**ADDENDUM #1
NCDOT TIP: EB-5014
LOVILLS CREEK AND ARARAT RIVER GREENWAY – MOUNT AIRY, NC**

ISSUED DECEMBER 11, 2014

LOVILLS CREEK AND
ARARAT RIVER GREENWAY
WORTH STREET TO THARINGTON PARK

3 GREENWAY ACCESS GATE

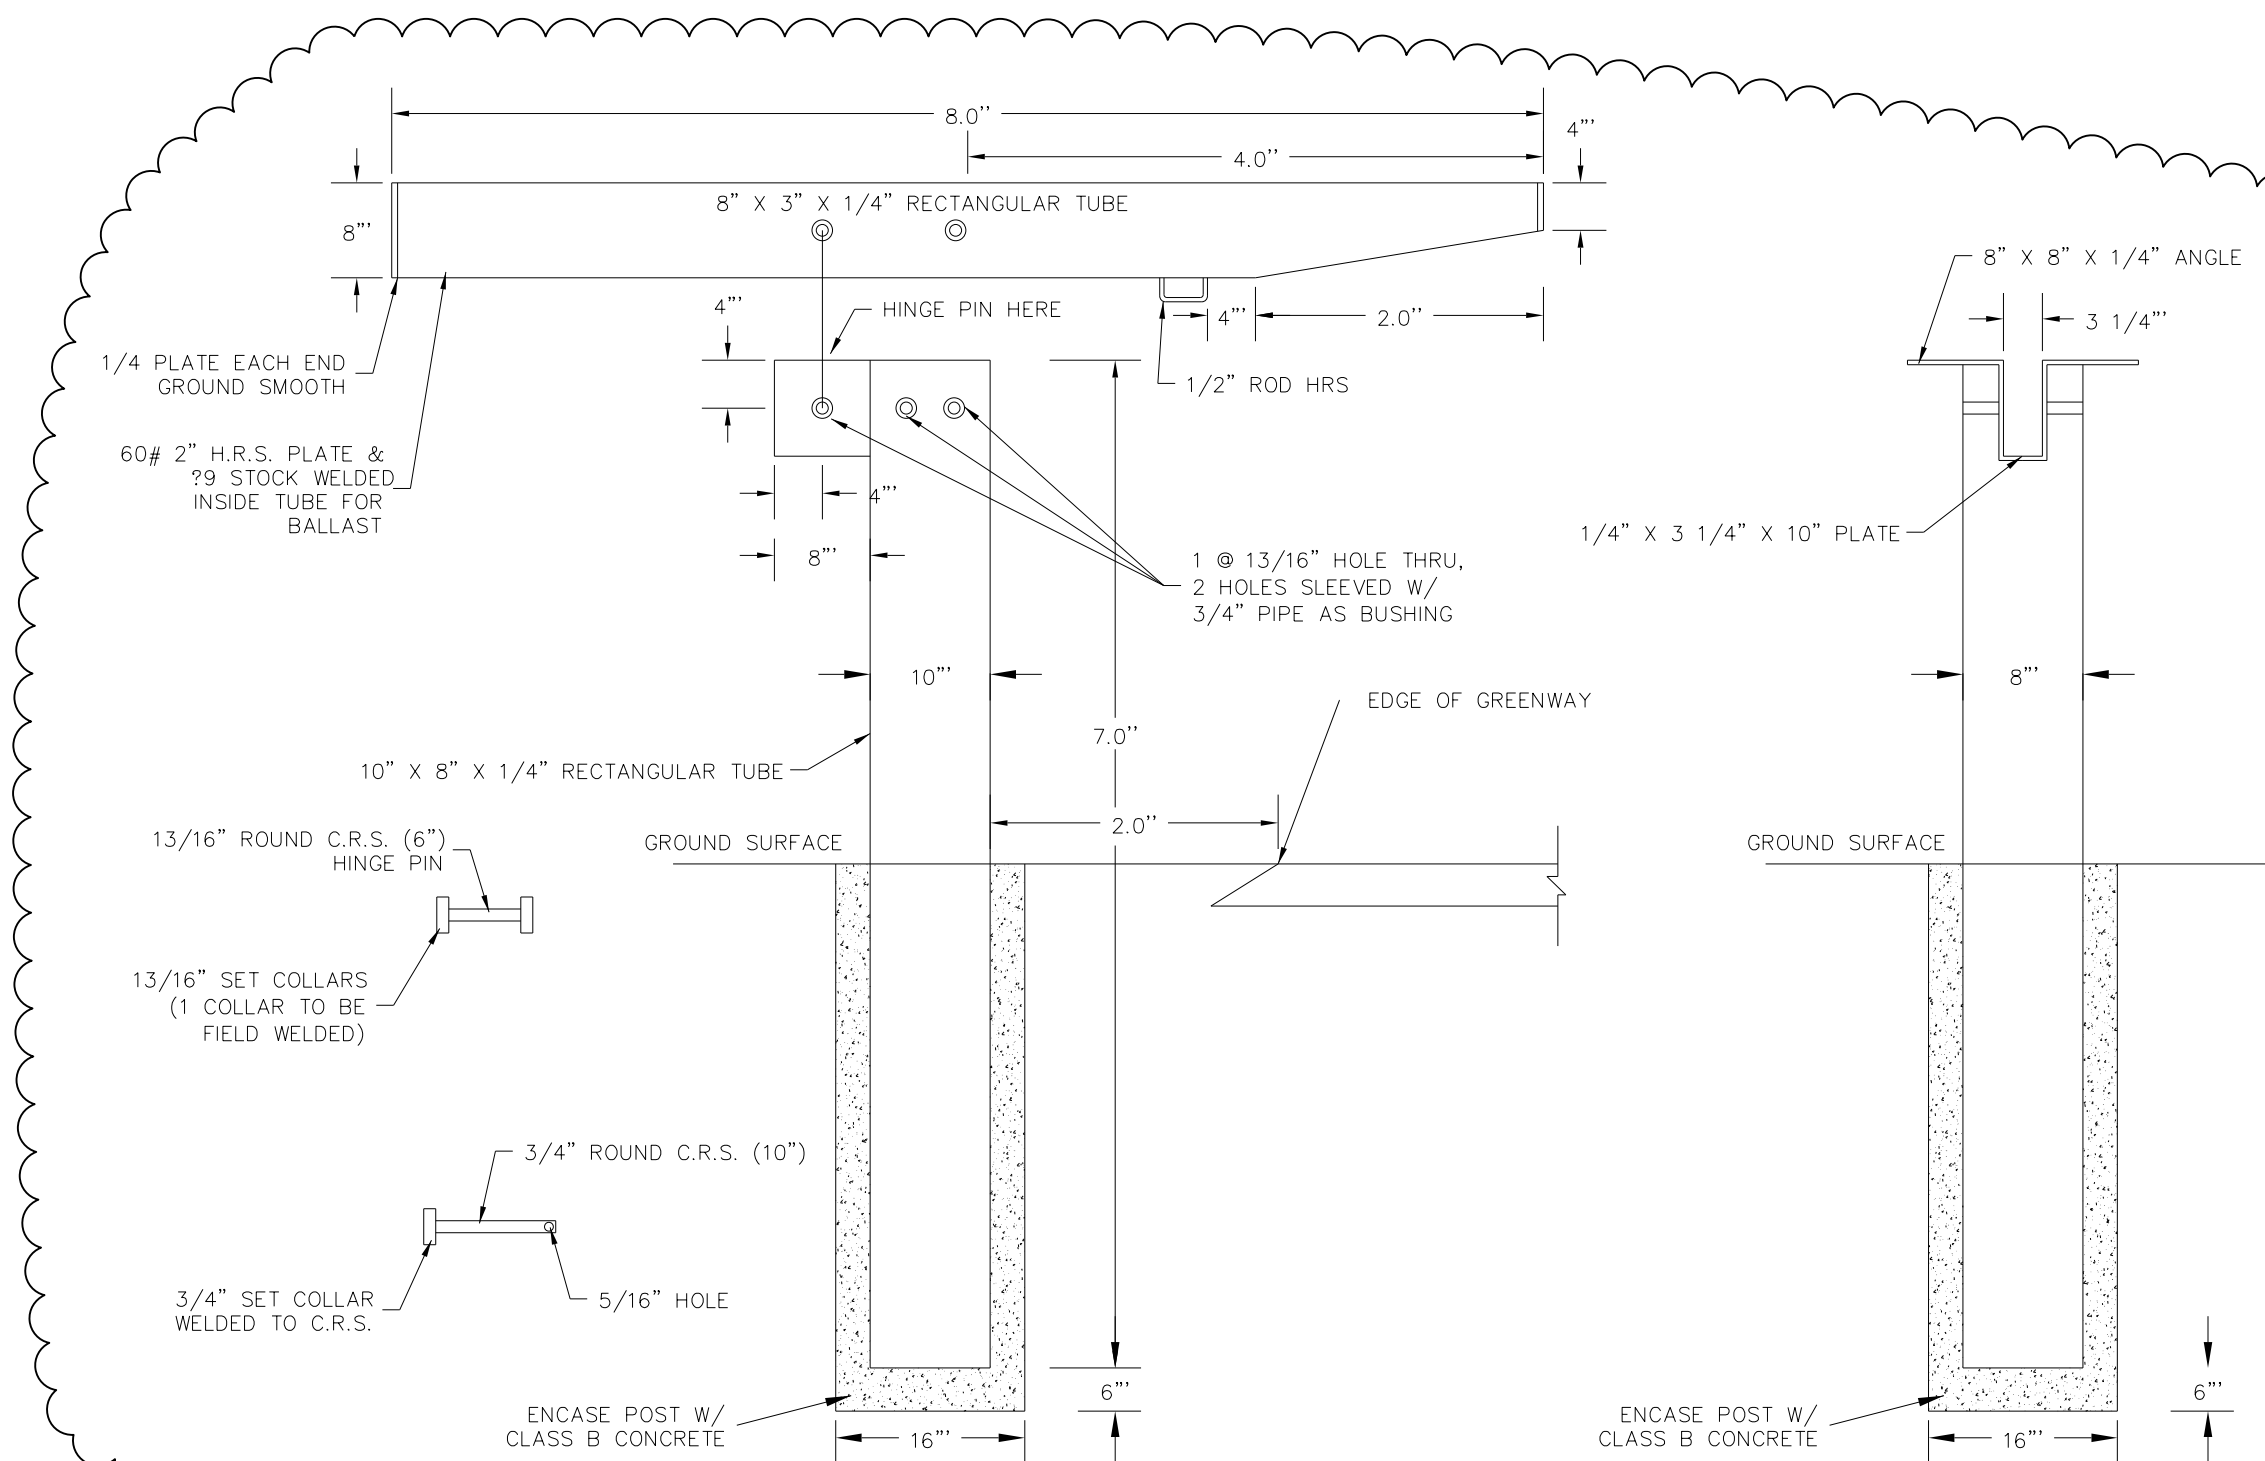
- Remove page 134 "INCIDENTAL STONE BASE" from the contract documents.
- An access gate detail has been added to Sheet 2E. Sheets 4 and 13 have been revised to show the locations of these access gates. A bid item has been added to the Bid Form, "ACCESS GATE", Item #100. Item #26 has been modified to "RELOCATE EXISTING ACCESS GATE". Page 165 of the contract documents has been deleted and replaced with a new special provision detailing the installation of new access gates and salvaging the old access gates at Worth Street.

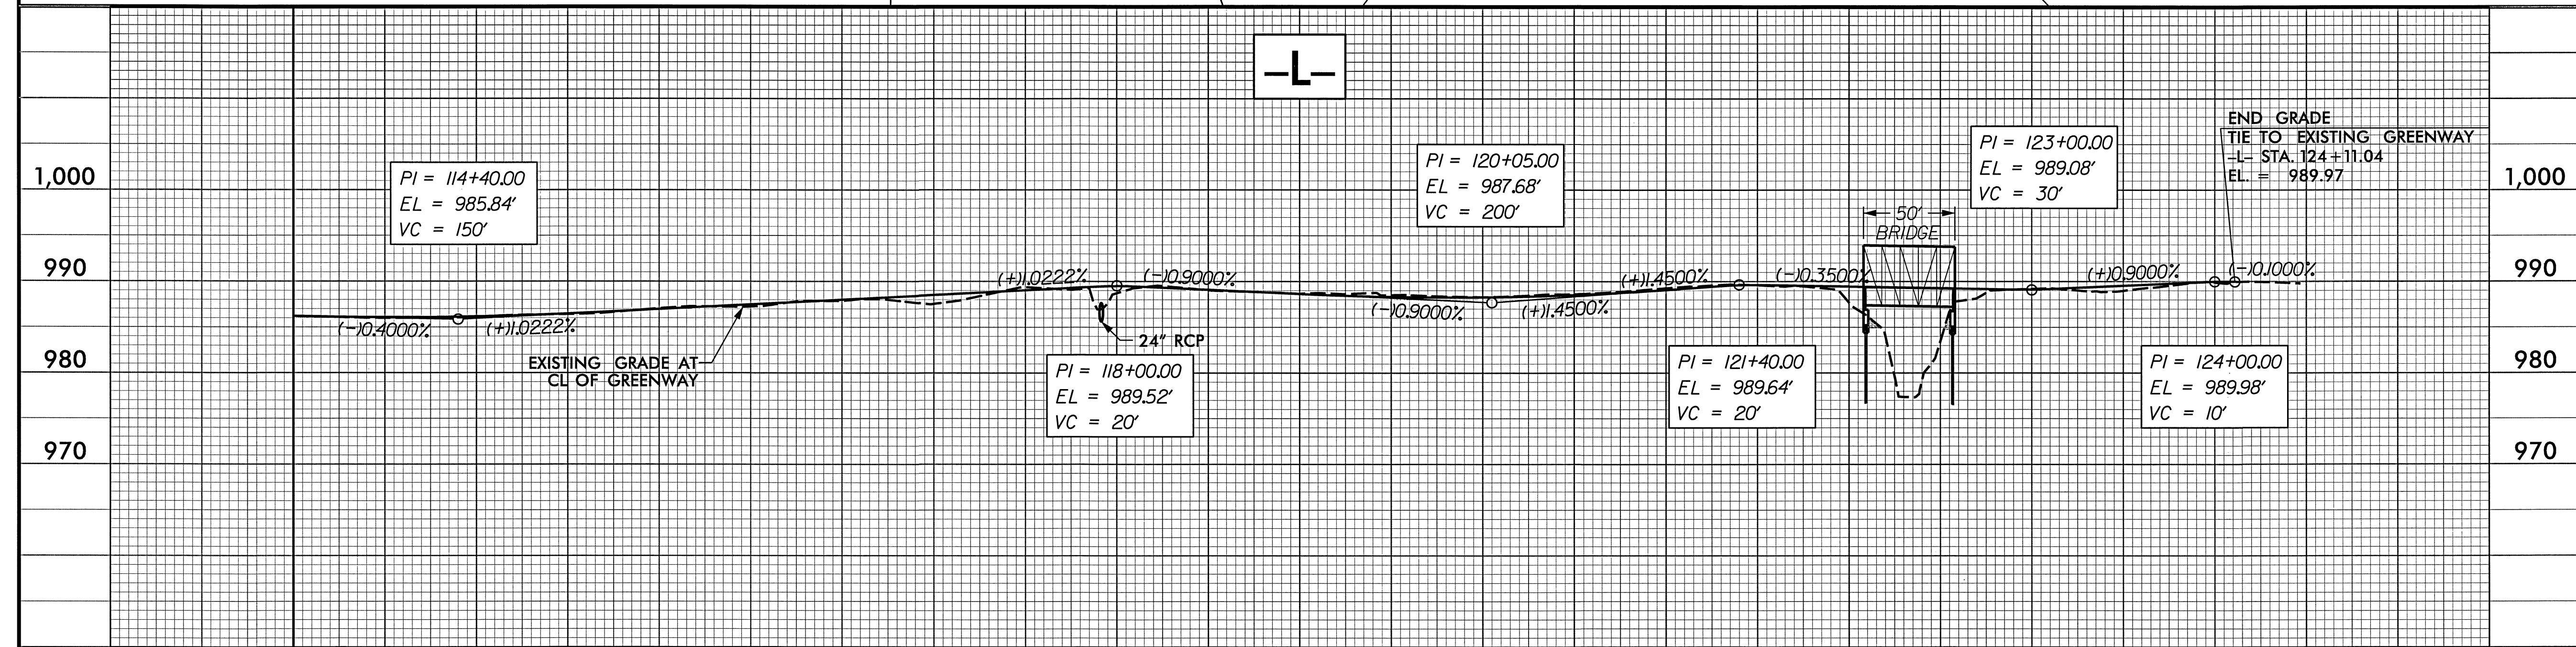
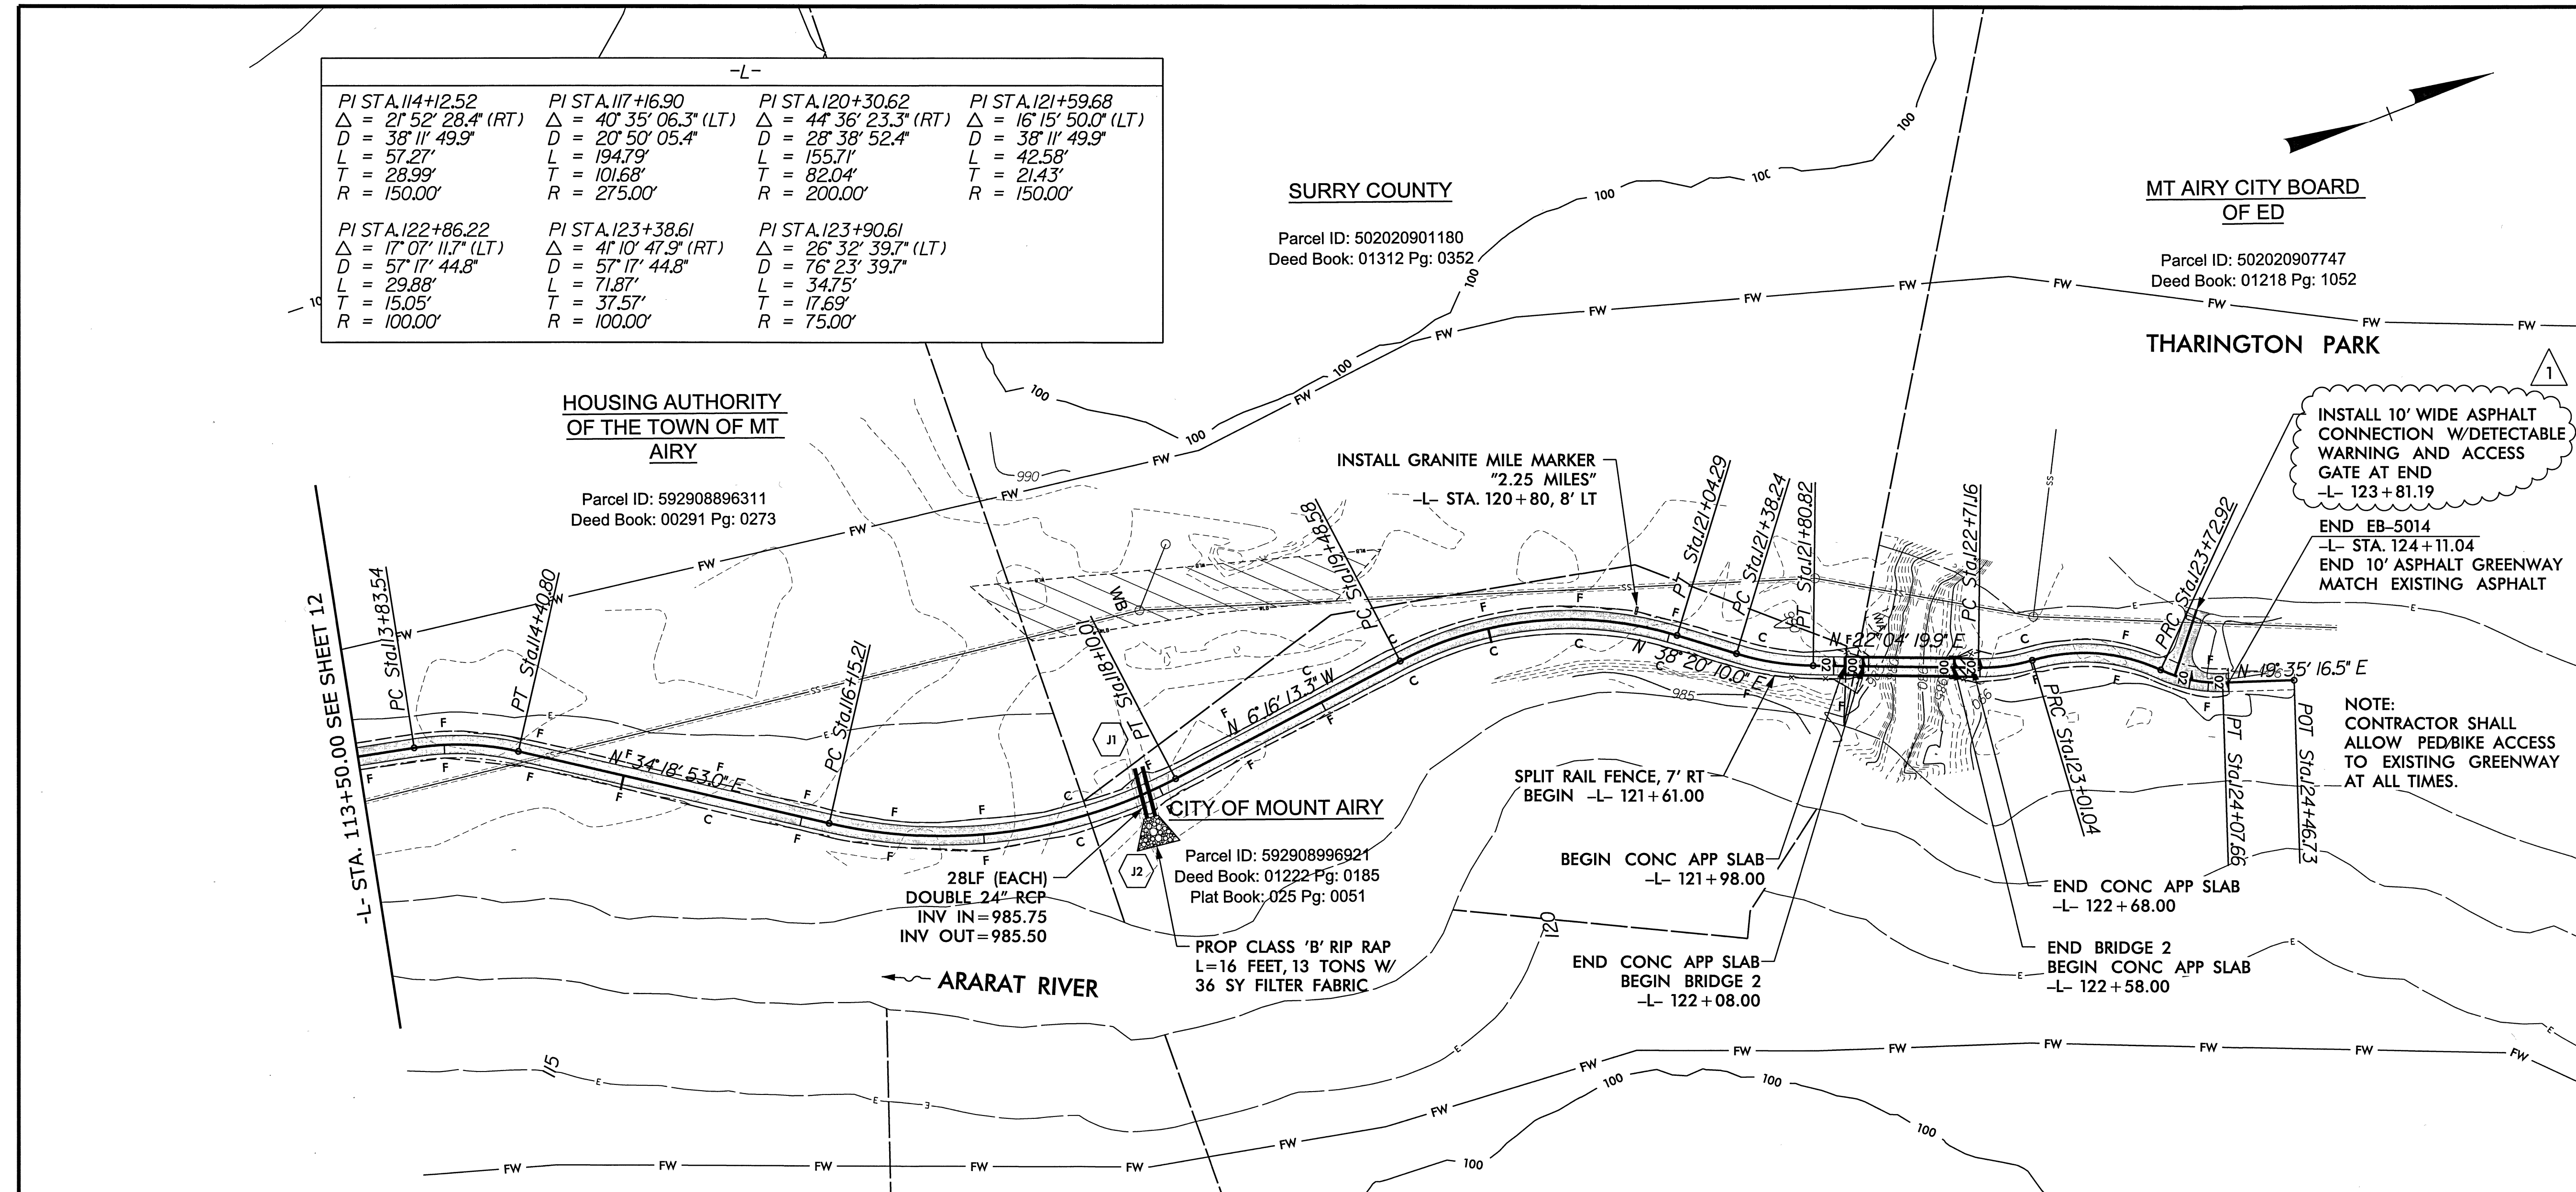
REMOVE ACCESS GATE ON EXISTING
GREENWAY AND INSTALL ON
PROPOSED GREENWAY
-L- STA. 9+25.00
